January 16, 2009

Docket No. 52-021
MHI Ref: UAP-HF-09002

Subject: MHI's Partial Responses to the NRC's Requests for Additional Information on Topical Report MUAP-07013-P (R0) "Small Break LOCA Methodology for US-APWR"

Figure RAI-4-3.1 Mechanism of loop seal formation

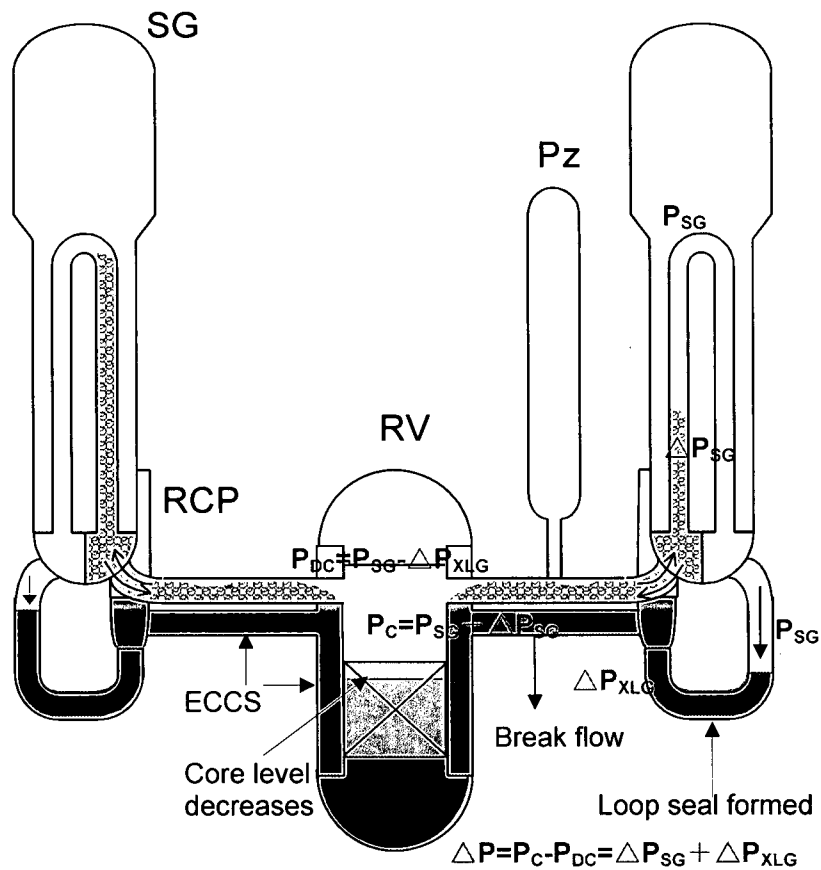
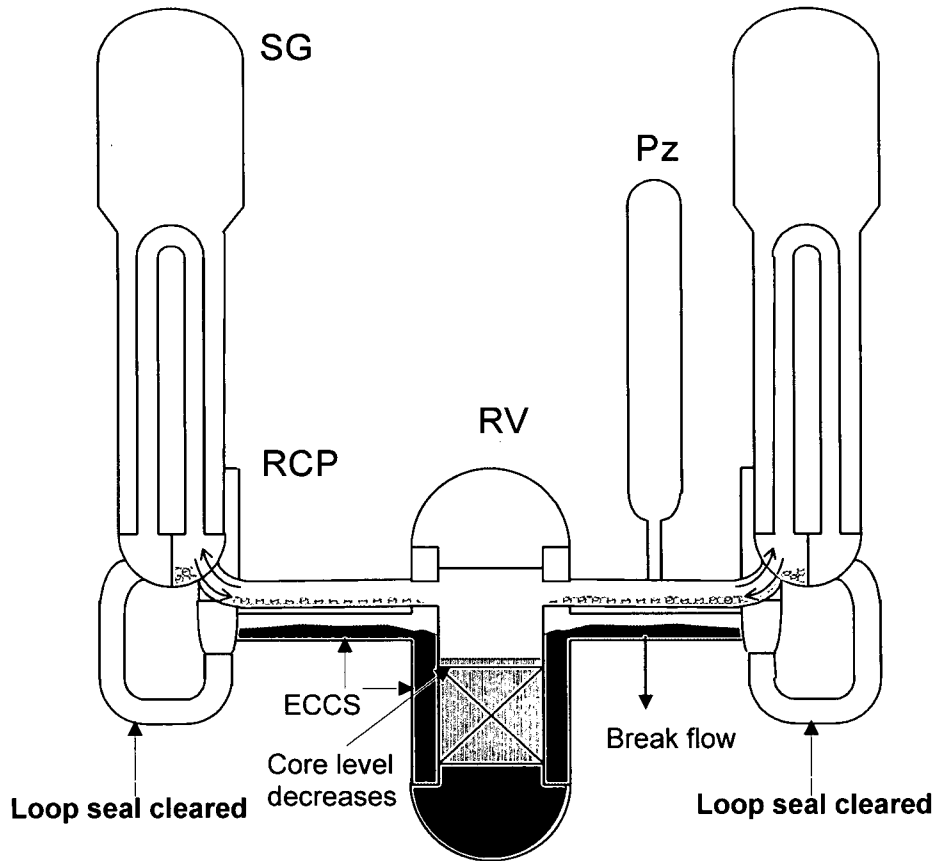
The responses to REQUESTs 4-1 and 4-2 above provide an improved description of the loop seal clearing mechanism. Figures RAI-4-3.1 and RAI-4-3.2 show the mechanisms of loop-seal formation and clearance.

Figure RAI-7-1.3 Collapsed liquid level in the vessel upper head

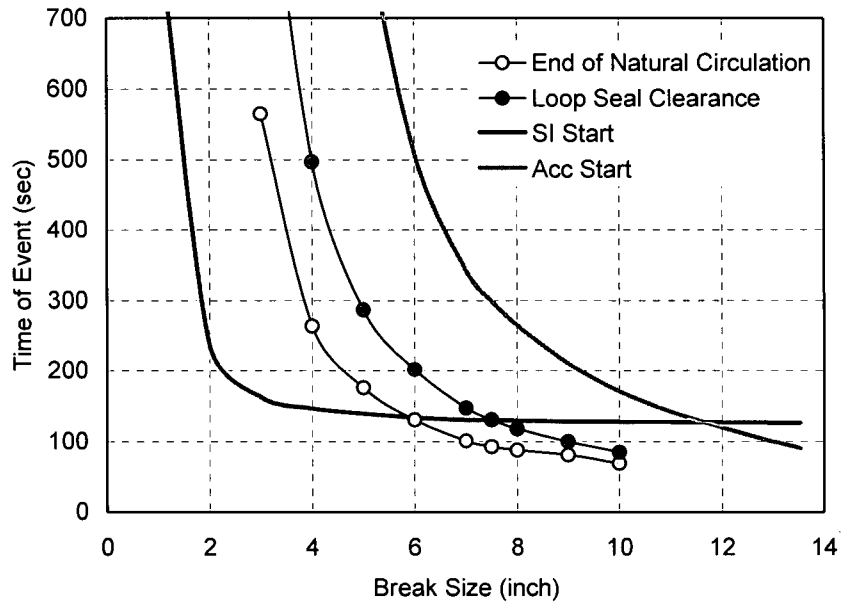
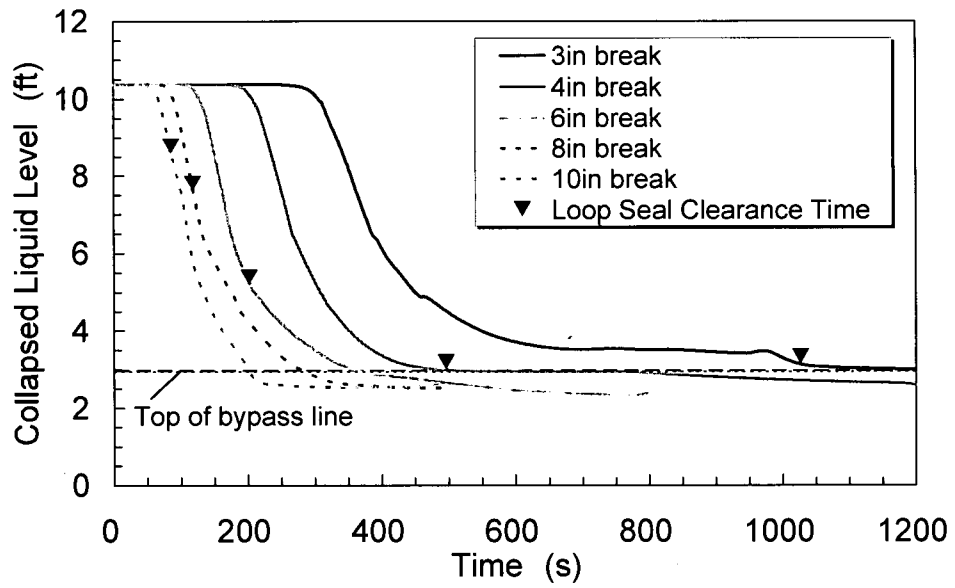
Appendix K requirement #15 ECC water bypass is taken as not applicable to SBLOCA. The bypass flow between upper head and downcomer could potentially provide a path for steam to enter the downcomer during the loop seal clearance period. Confirm that none of the SBLOCA analyses, including sensitivity cases, experience the effect of steam impeding ECC flow.

As the loops are sealed at the cross-over legs during the loop seal clearance period, upper head/downcomer bypass flow path has the potential for relieving vapor generated in the core. The break size spectrum analyses for the cold leg break are performed for US-APWR (Ref.1). The loop seal clearance periods for various break sizes are shown in Figure RAI-7-1.1. The assumed break orientation for these cases is the bottom of the cold leg. ECC water injection start time of the high head safety injection systems and the accumulators are also shown in Figure RAI-7-1.1. Only the high head safety injection system injects ECC water during the loop seal clearance period.

ECC water from the high head safety injection systems is injected into the downcomer in the downward direction between the vessel wall and the barrel wall through the direct vessel injection line shown in Figure RAI-7-1.2. So, even if the steam flow through the bypass line exists, it does not impede ECC flow into the core.

The collapsed liquid level transients in the vessel upper head and the end of the loop seal clearing period for several break sizes are shown together with top of bypass line elevation in Figure RAI-7-1.3. The bypass line is covered by the water during the loop seal clearance period. So, the vapor generated in the core hardly escape to the downcomer through the bypass line.

Figure RAI-7-3.1 M-RELAP5 noding scheme

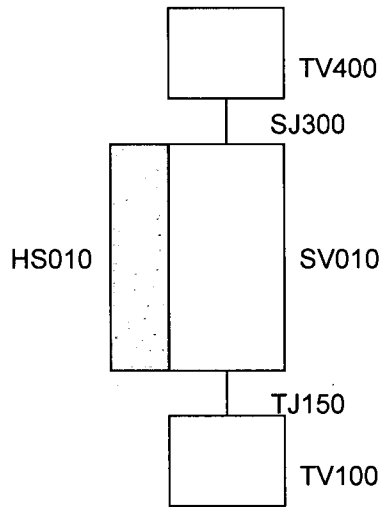
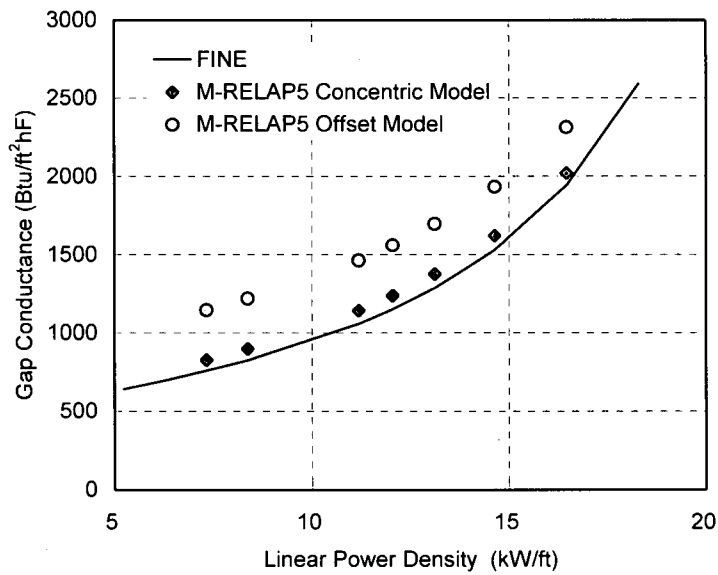
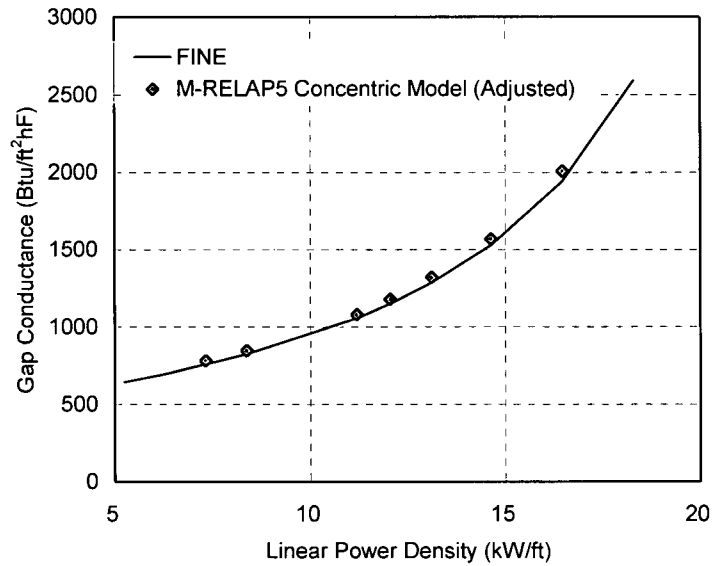
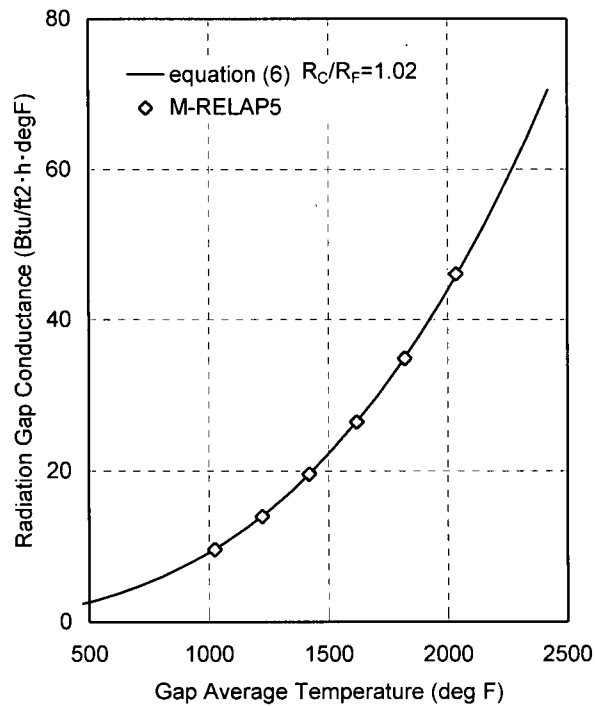
The discussion of gap conductance model is in the form of one equation and one reference to the fuel design code FINE. Provide validation analysis of the gap conductance model as expressed in Equation (7.1.2-1). Provide verification of the implementation of the gap conductance model in M-RELAP5 and demonstrate the integration of the gap conductance model with the rest of the gap heat transfer model in RELAP5-3D, such as thermal radiation across the gap.

M-RELAP5 nodding scheme is shown in Figure RAI-7-3.1. Heat structure HS010 represents a fuel rod, and single volume SV010 represents fluid volume containing the fuel rod. Vapor temperature of time dependent volume TV100 is selected so that the calculated cladding surface temperature agrees with that predicted by FINE. Pressure of time dependent volume TV400 is adjusted to make the SV010 pressure to be 2250psia. Internal pressure calculated by FINE is used in M-RELAP5. The input values for surface roughness of the fuel and cladding for M-RELAP5 are selected so that the effect of surface roughness on gap conductance is same between M-RELAP5 and FINE.

The comparisons of the calculated gap conductance by M-RELAP5 and FINE are shown in Figure RAI-7-3.2. The gap conductance is also calculated by M-RELAP5 using the pellet offset gap conductance model presented in equation (1). The pellet offset gap conductance model gives larger values than FINE. On the other hand, gap conductance with the concentric gap conductance model agrees with the prediction by FINE. However, a small difference remains between the two predictions. Two causes are pointed out. First, the gap conductance by M-RELAP5 includes the additional thermal radiation term across the gap. But, its contribution to the gap conductance is too small at normal conditions to explain the difference as discussed later. Next, as M-RELAP5 uses the same thermal expansion models for cladding and fuel as RELAP5-3D, the applied thermal expansion models for cladding and fuel are different between M-RELAP5 and FINE. These differences affect the predicted gap size by each code. The gap conductance calculated by M-RELAP5 is divided by the ratio of gap size calculated by FINE to gap size calculated by M-RELAP5. The obtained gap conductance agrees well with that by FINE shown in Figure RAI-7-3.3. It is concluded that the concentric gap conductance model consistent with FINE is adequately implemented in M-RELAP5.

M-RELAP5 uses the same thermal radiation term as RELPA5-3D. Radiation gap conductance mainly depends on the gap average temperature, and slightly depends on the ratio of outer fuel radius to inner cladding radius. Radiation gap conductance dependency on the average gap temperature is shown in Figure RAI-7-3.4.

Fuel rod temperatures are increased by setting the vapor temperature of time dependent volume TV100. The obtained radiation conductance is shown in Figure RAI-7-3.4. It agrees with the prediction with equation (6). It is concluded that the radiation conductance model across the gap is adequately implemented in M-RELAP5.

Figure RAI-7-5.1 M-RELAP5 noding scheme

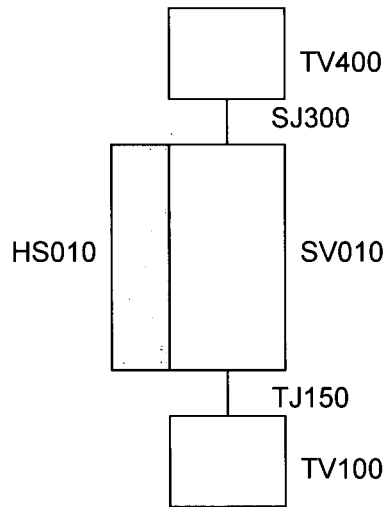
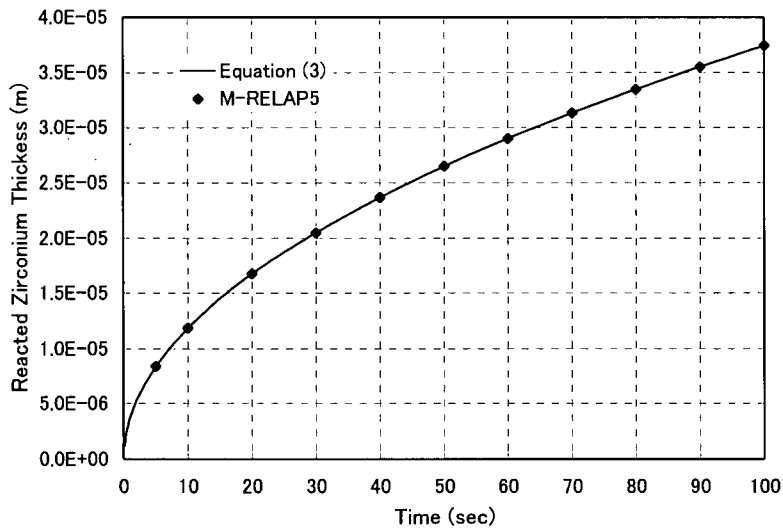
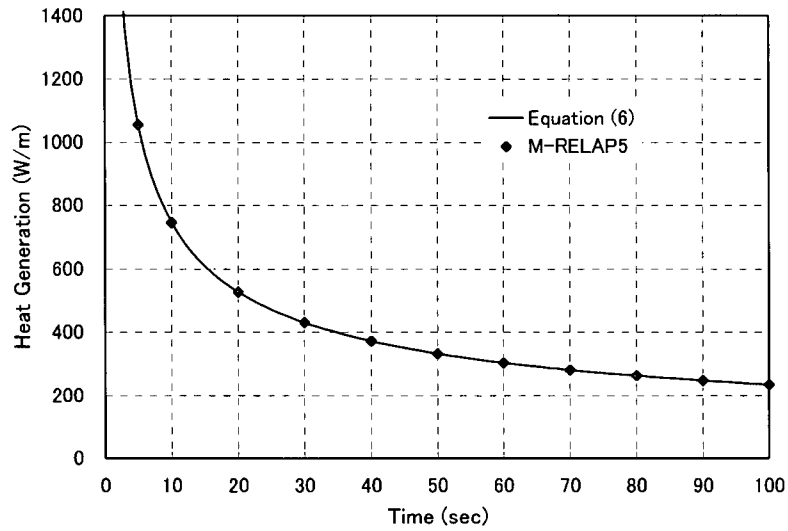
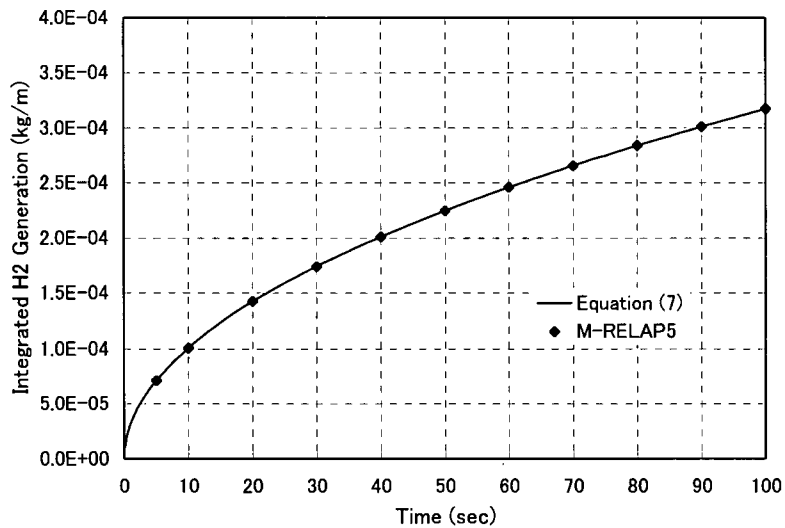
Provide verification of the implementation of the Metal Water Reaction Rate Model in M-RELAP5. Confirm that the hydrogen generation rate and the heat generation rate are consistent with the metal/water reaction rate.

The thickness of the cladding converted to oxide, the metal-water reaction heat release rate, and hydrogen mass generated by the metal-water reaction at an isothermal condition are calculated by M-RELAP5 and are compared with analytical calculation results to verify that the Baker-Just correlation is adequately implemented in M-RELAP5.

M-RELAP5 nodding scheme is shown in Figure RAI-7-5.1. Heat structure HS010 represents a fuel rod with 100mm axial length, and single volume SV010 represents fluid volume containing the fuel rod. Vapor temperature of time dependent volume TV100 is set to be 1200 deg C and junction vapor flow of time dependent junction TJ150 is set to be 1.0×10^6 kg/s to maintain the cladding surface temperature at 1200 deg C. Fluid pressure is maintained to be 10MPa by time dependent volume TV400. Fission and decay heat power are neglected and a large rod surface heat transfer coefficient is applied so that the metal-water reaction heat rate can be estimated from the heat transfer rate from cladding to vapor. Cladding swelling and rupture calculations are skipped so that the M-RELAP5 and analytical results can be easily compared.

The comparisons of the calculated results of the zirconium reacted thickness, the reaction heat release rate and the hydrogen mass generated by M-RELAP5 with the results by equation (3), equation(6) and equation (7) are shown in Table RAI-7-5.1 and Figure RAI-7-5.2, Figure RAI-7-5.3 and Figure RAI-7-5.4. The calculated results by M-RELAP5 agree with the results by the analytical method well. It is concluded that the Baker-Just correlation is adequately implemented in M-RELAP5 and the hydrogen generation rate and the heat generation rate are also adequately calculated.
